96N120 PH 6 SUBDIVISION PLAT

DATE DESCRIPTION
GREAT BASIN	B E N G I N E E R I N G C	5746 SOUTH 1475 EAST OGDEN, UTAH 84403 Main (801)394-4515 S.L.C (801)521-0222 FAX (801)392-7544 W W W . G R E A T B A S I N E N G I N E E R I N G . C O M	REV
Plan / Profile (Utility)	The Chalets at Ski Lake No. 7	A part of the Southwest 1/4 of Section 13, a part of the Northeast 1/4 of Section 23, and a part of the Northwest 1/4 of Section 24,	T6N, R1E, SLB&M, U.S. Survey
Not 166484 MARK EUGENE BABBITT Jan, 2012 SHEET NO.

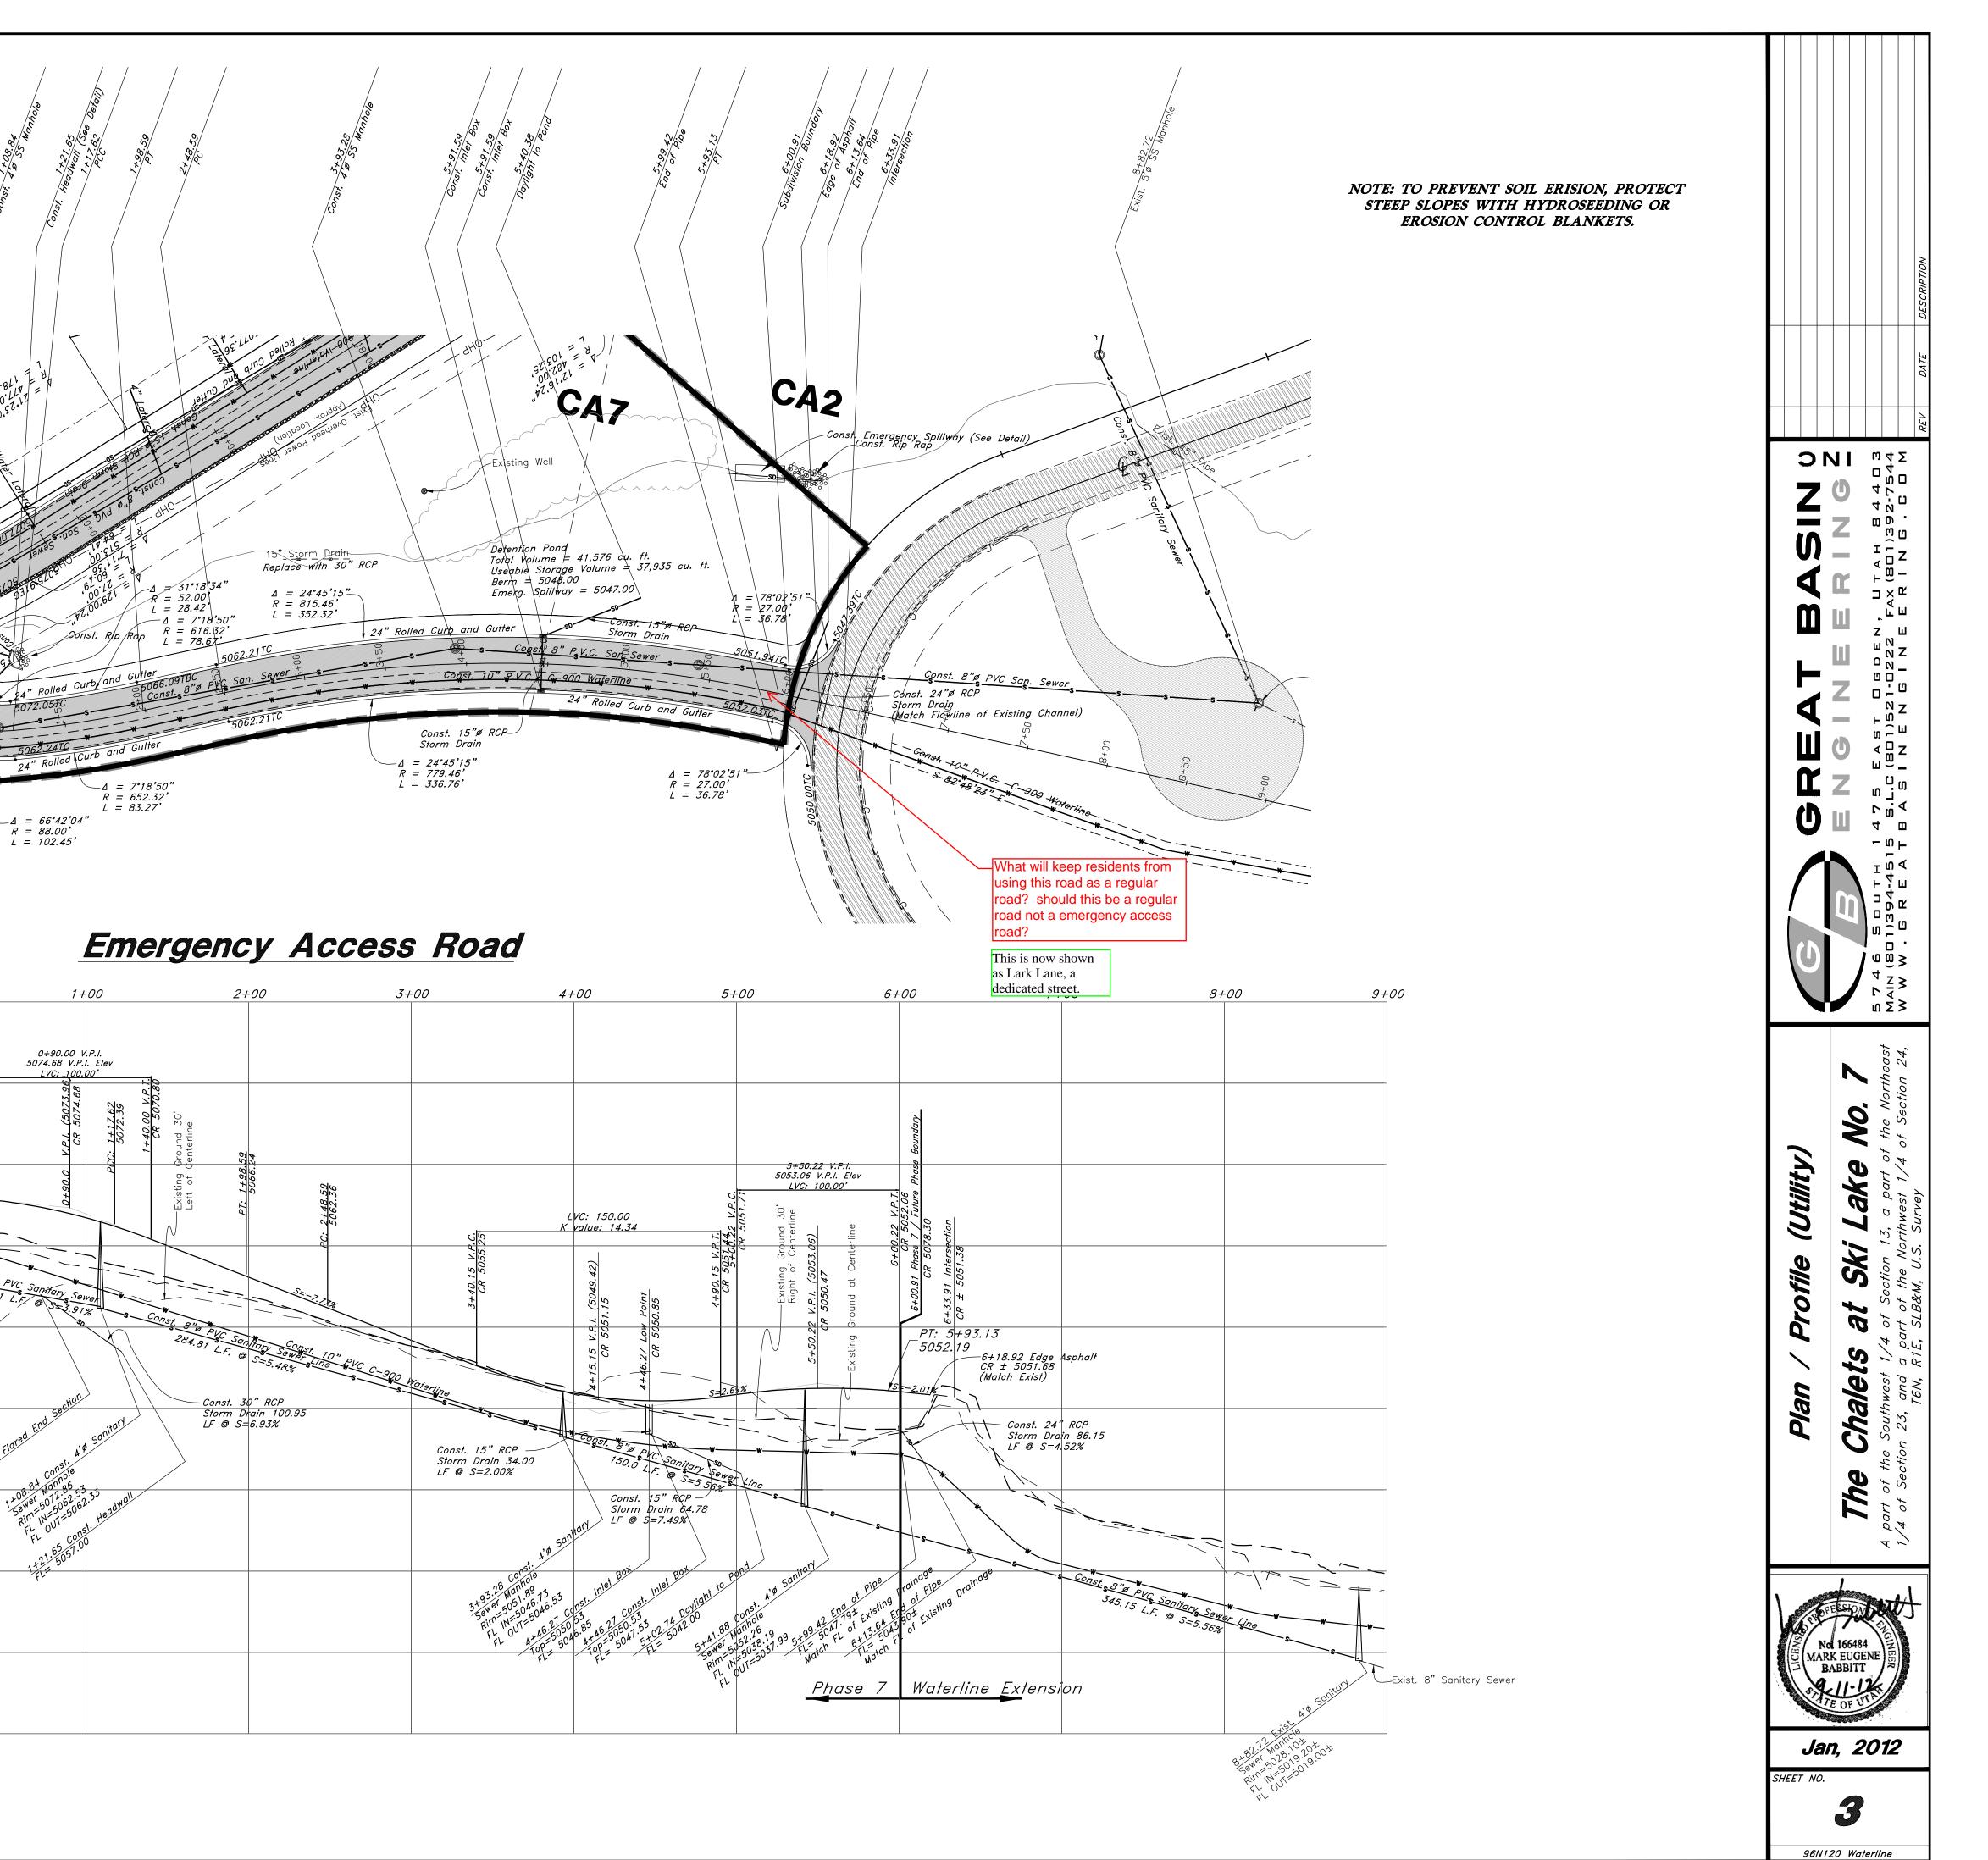
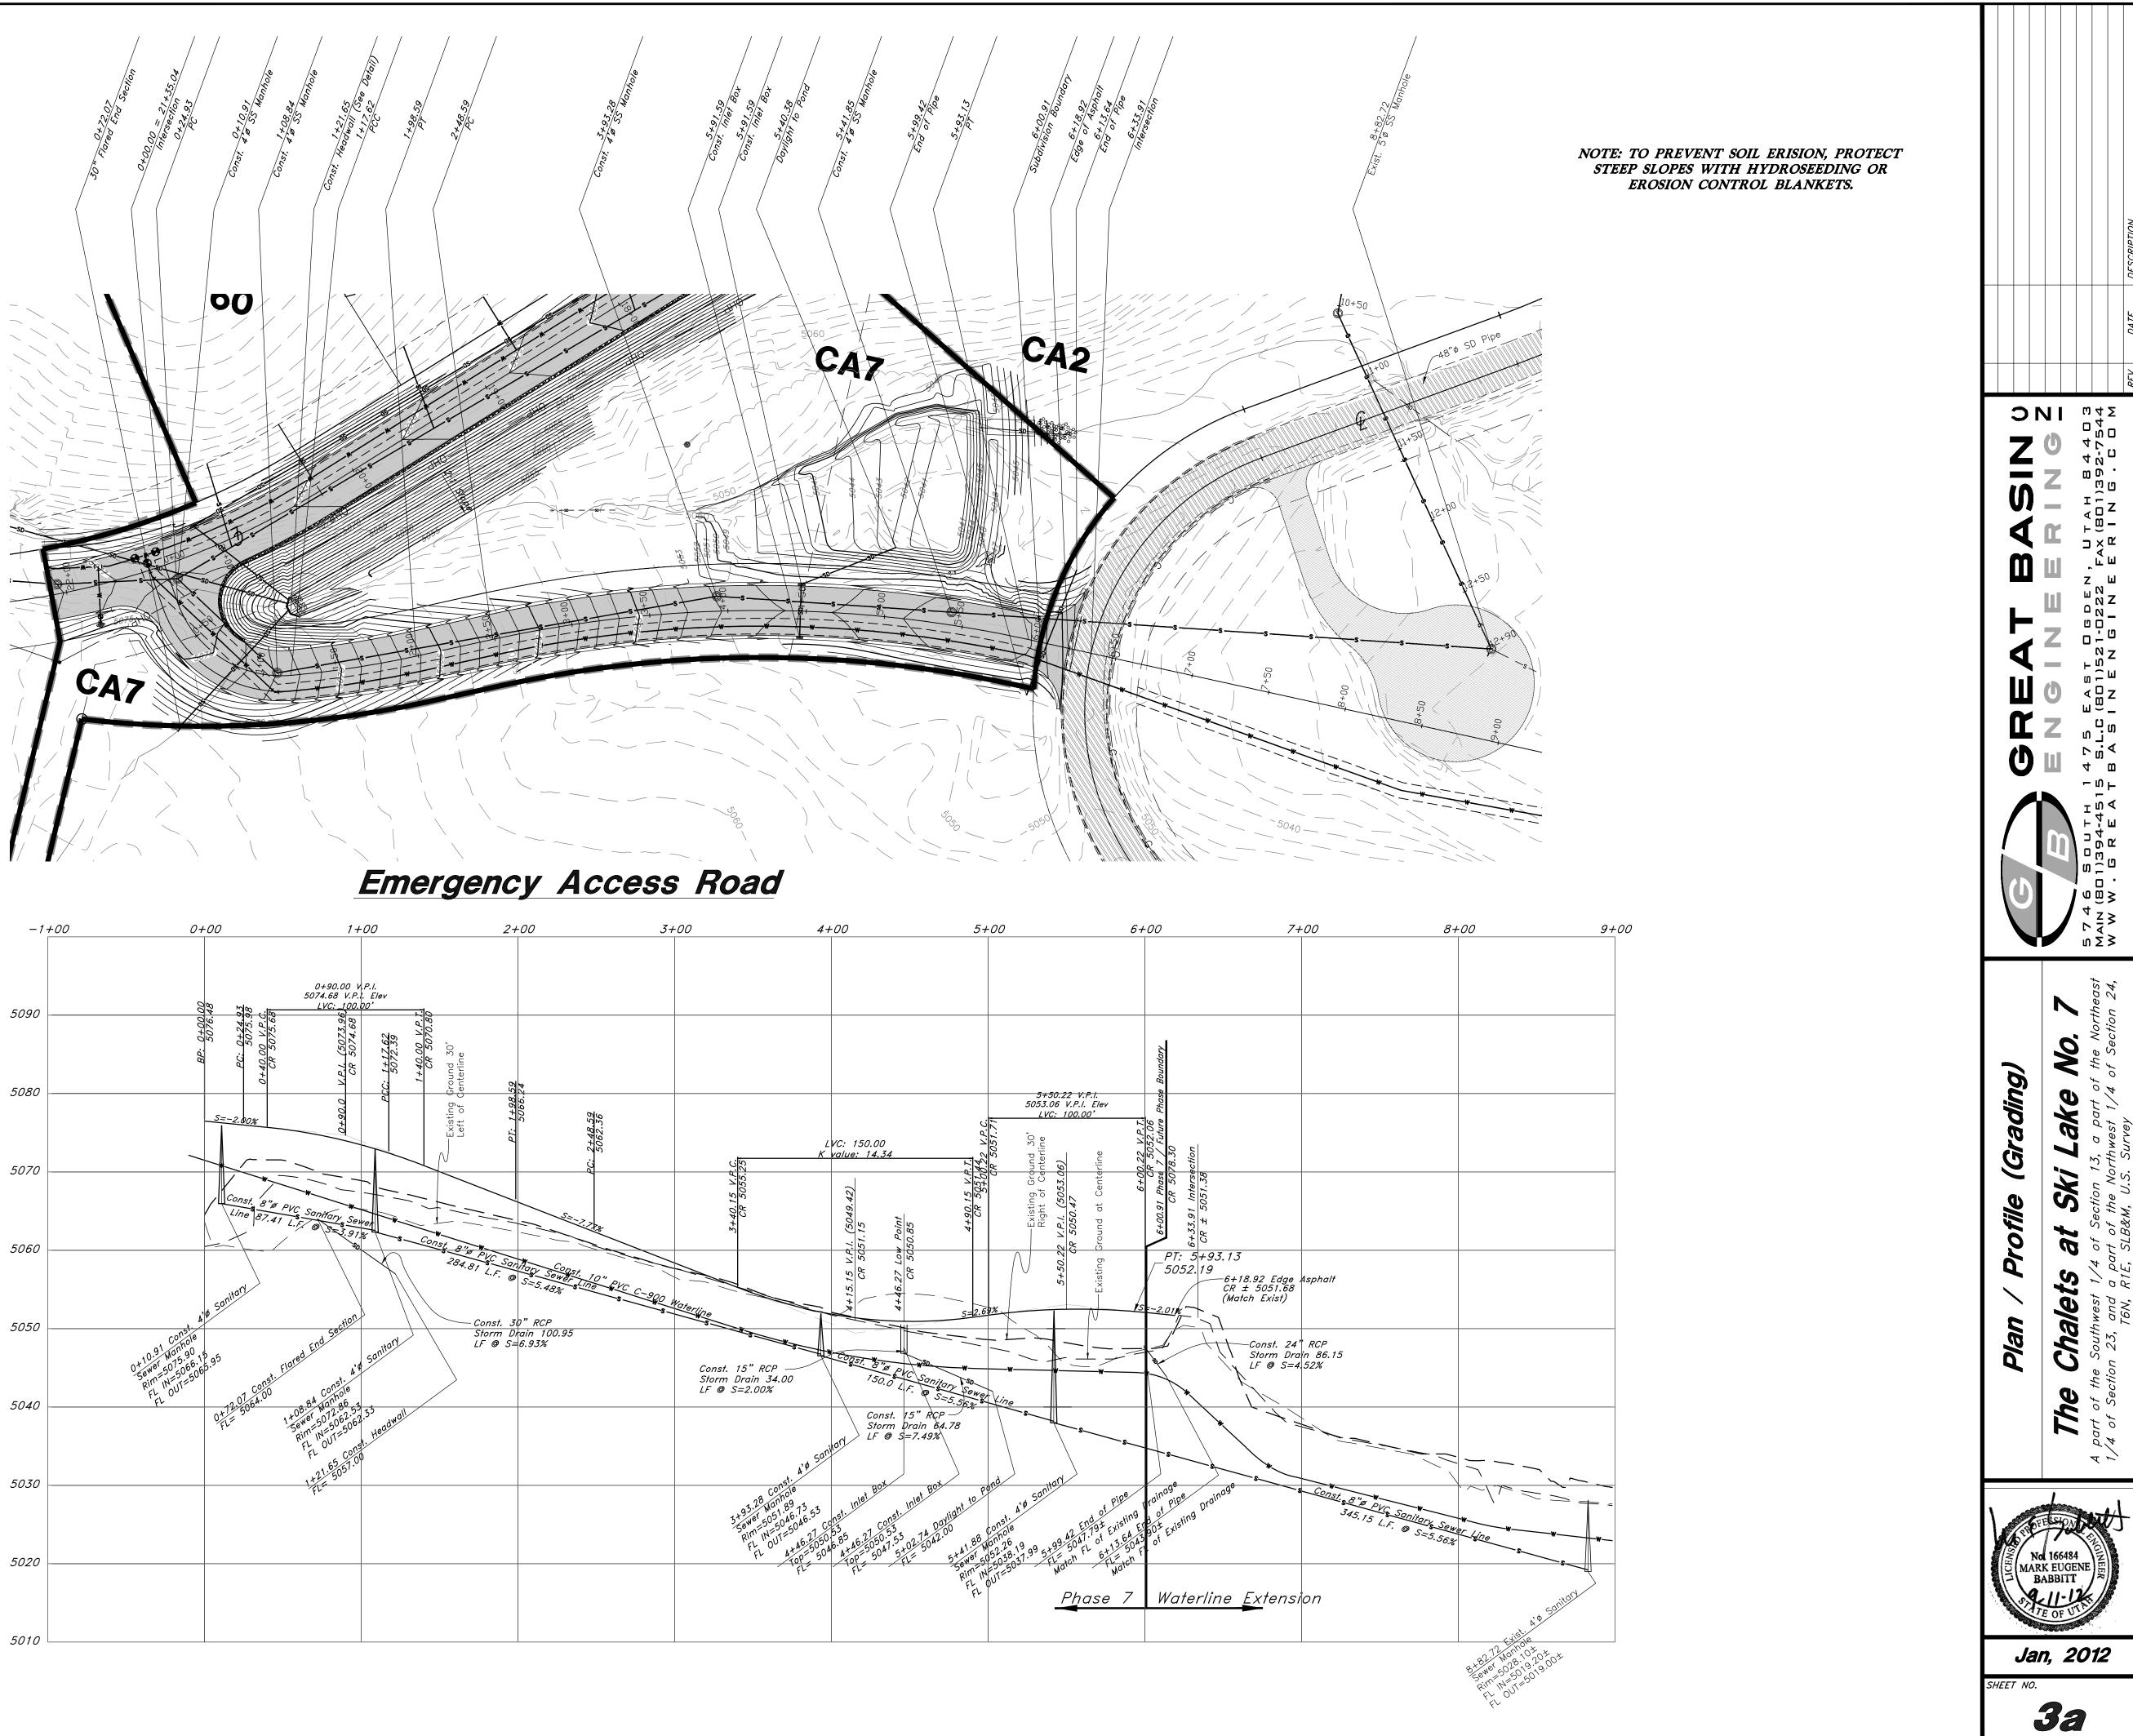
How was the sizing – of these pipes determined? What are the flows they are taking? See attached Storm

Water Study for calcs on these two pipes.
